# PERMIT

SEWAGE DISPOSAL SYSTEM

A Repair

PROPERTY OWNER Mr. & Mrs. William Staben

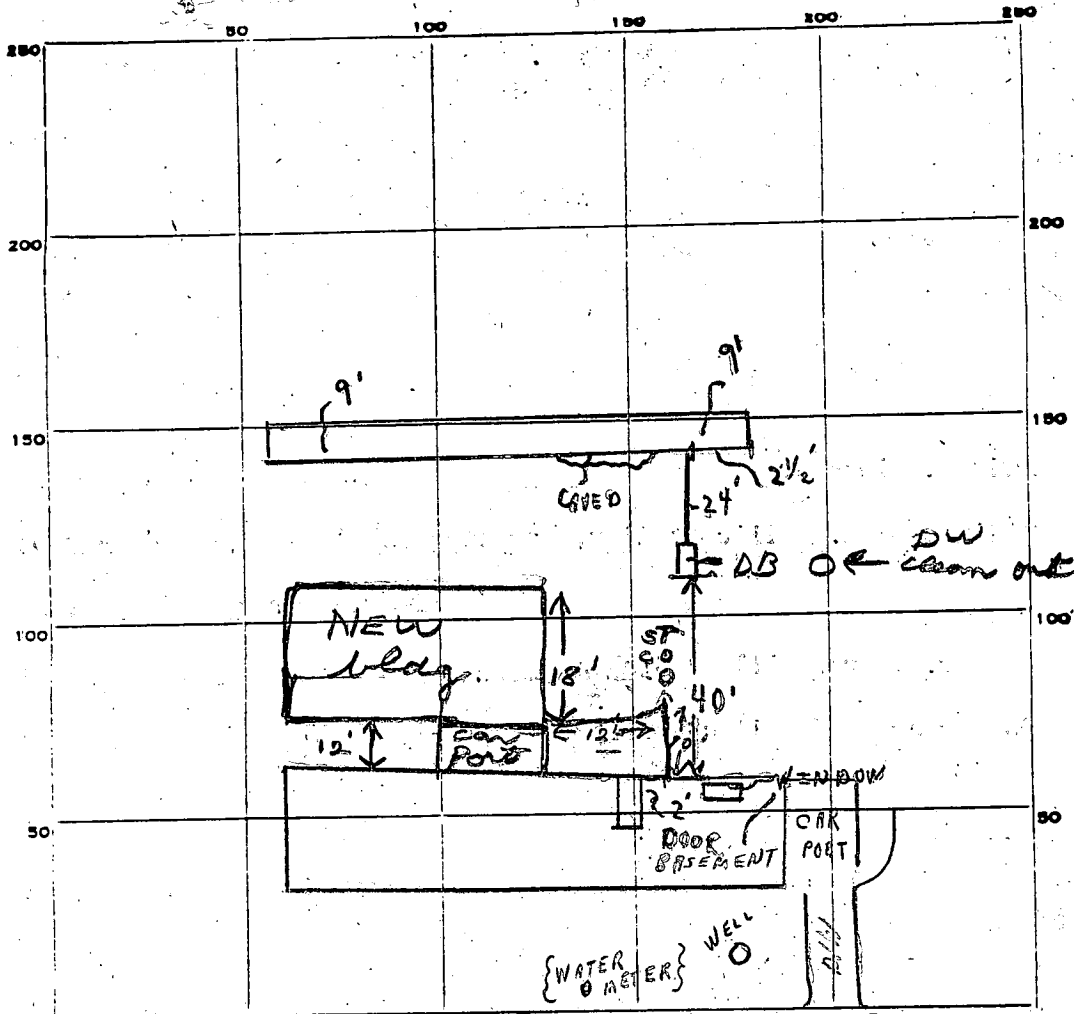
REMARKS 8/17/81(1) TRENCH ONLY OK FOR STONE - IN AREA CALLED FOR;  
NEED CLEANOUTS TO GRADE AT SEPTIC TANK AND 1 DRY WELL; NOTE  
1 DRY WELL TO BE CAVED IN. (2) TRENCH COMPLETE - OK TO COVER  
TO 2' OF DIST. BOX; NEED CLEANOUT @ DRY WELL + PIPE CEMENTED  
AT DISTRIBUTION BOX. BOTH NEW AND 1 OLD ONE TO FILLED DRY WELL;  
NEED TO SEE NEWLINE FROM ADDITION TO OLD SEPTIC TANK ALSO  
PARTIAL. (3) NO CHANGE 8/18/81 - work OK - OK to cover - Must see new line  
 DATE SYSTEM APPROVED 9/25/81 INSPECTOR Stayer

HOLE ELEVATIONS

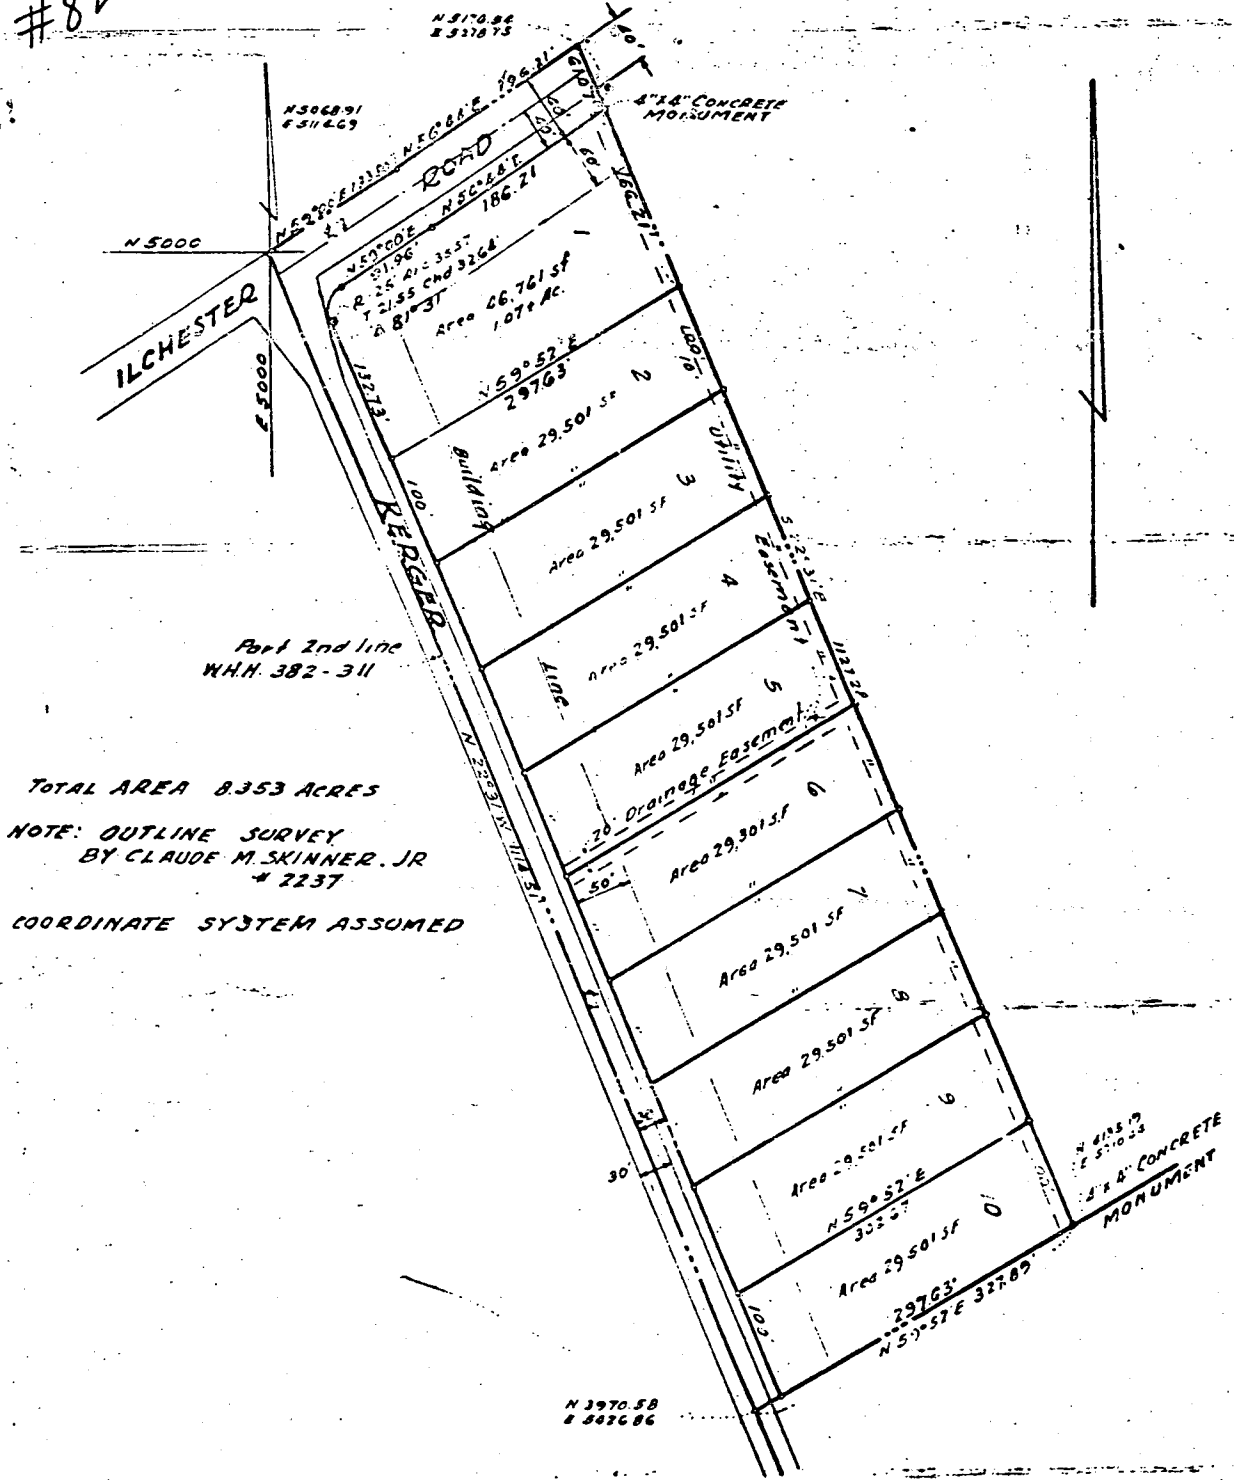
8/28/80 T.C.E Mr. Staben  
 size of addition to be 20x30  
 I requested drawings showing  
 lot lines, distances and  
 size of existing & proposed  
 structures. P.S.

Per OK for Ditch But want Drawing showing location of addition before F.S. before writing spec.

PLOT PLAN WITH  
SEPTIC SYSTEM REVISIONS

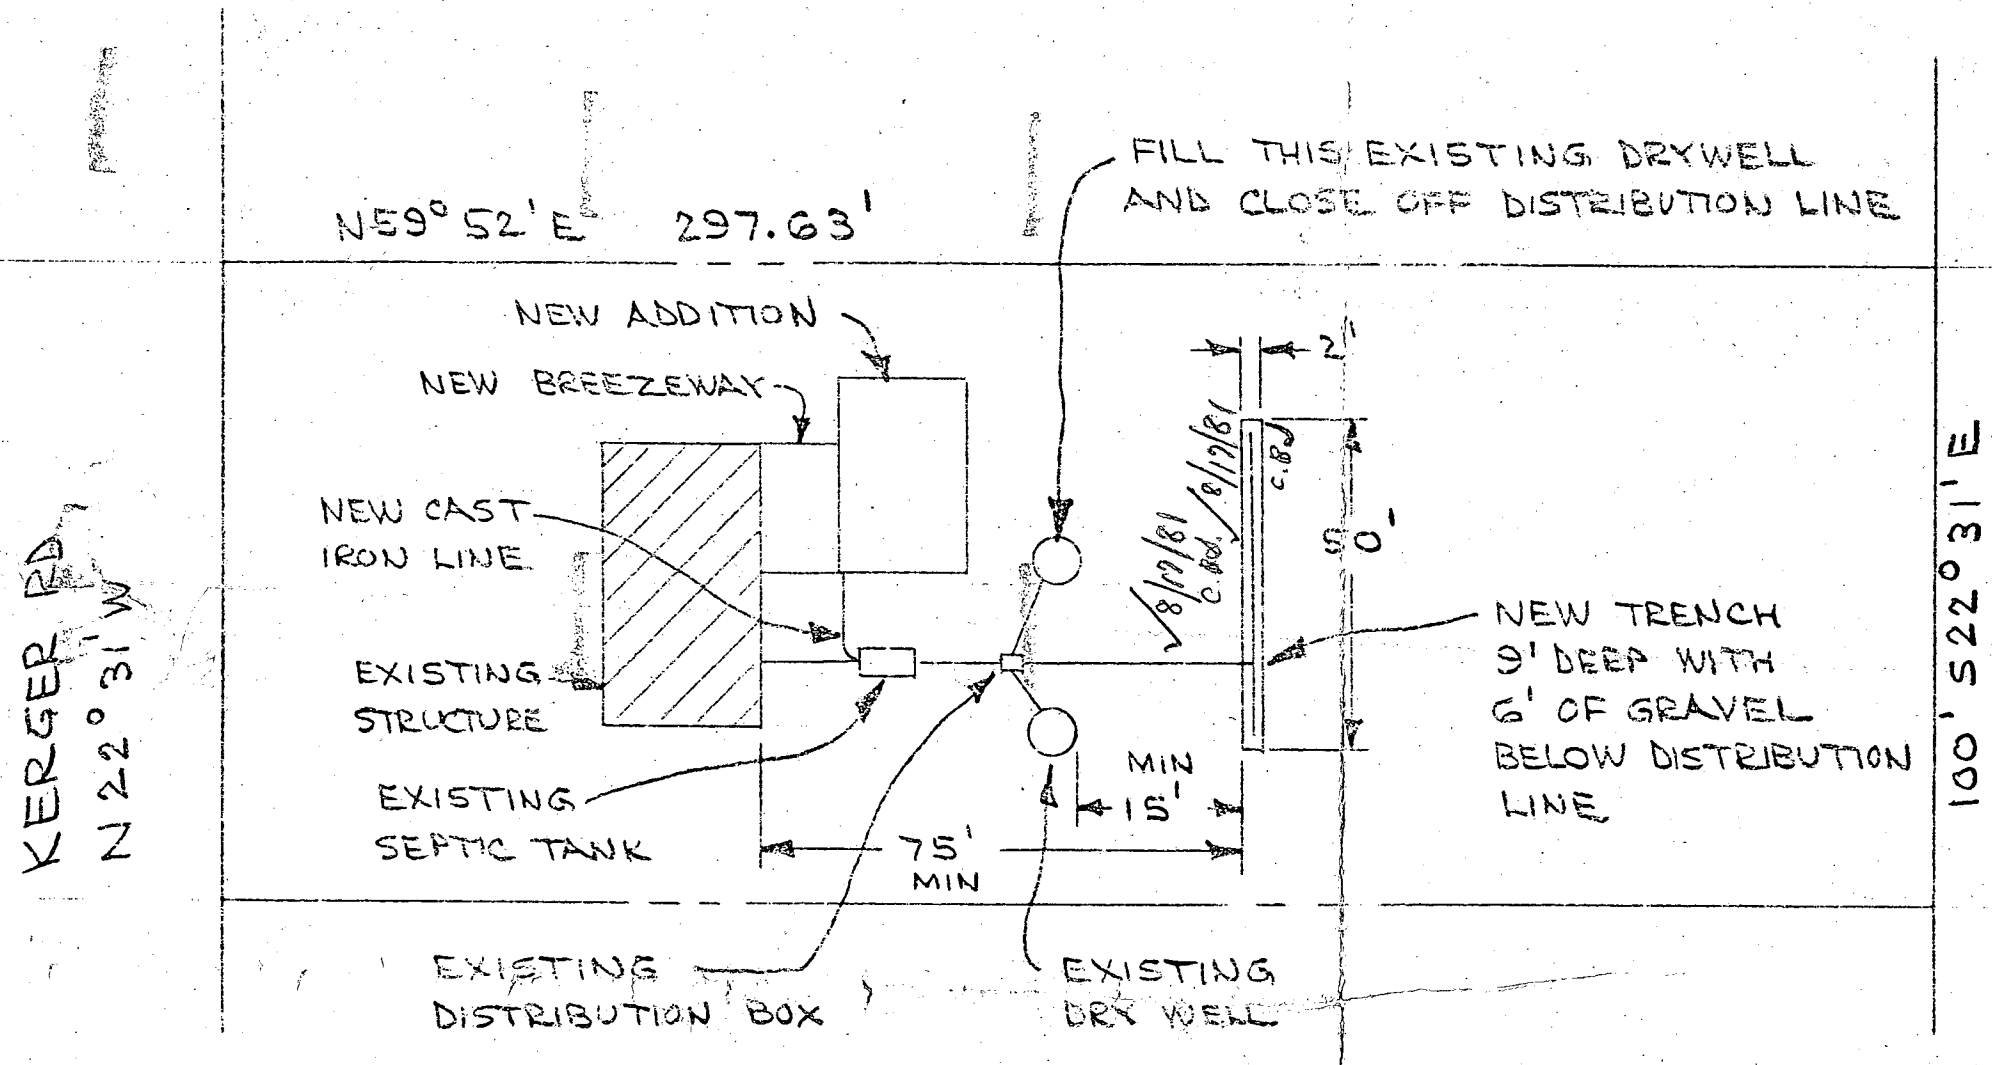
6/24/81  
 Sketch O.K.  
 J.S.
